Access Compliance Report

Public Rights-of-Way

Intersection ID: N/A	Main Street: CANTERBURY_CASTLE_DR	Cross Street: BELVEDERE_CASTLE_DR	Location: E
ADA ID: E1C1A0E5288A	Ramp Type: BlendTrans1	Initial Pass/Fail: Fail	Overall Compliance: No
Severity Score: 8.75			
Codes/Mitigation Info/Possible Solution		Field Measurements/Component Compliance

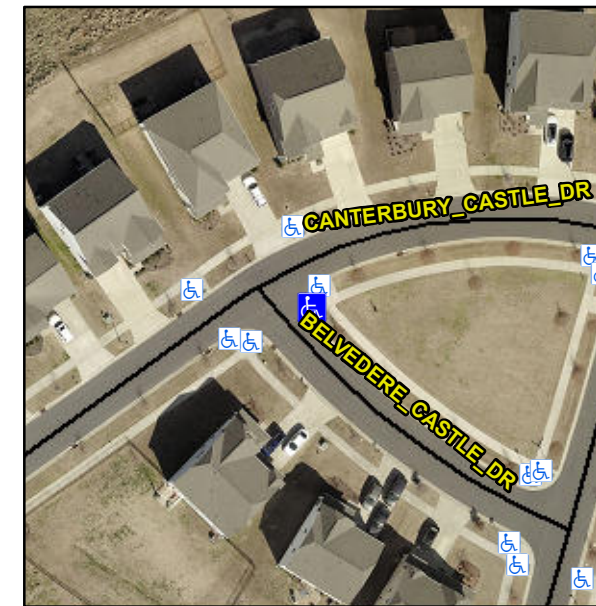
R304.5.1

Remove & Replace Curb Ramp With Two New Directional Ramps or Equivalent.
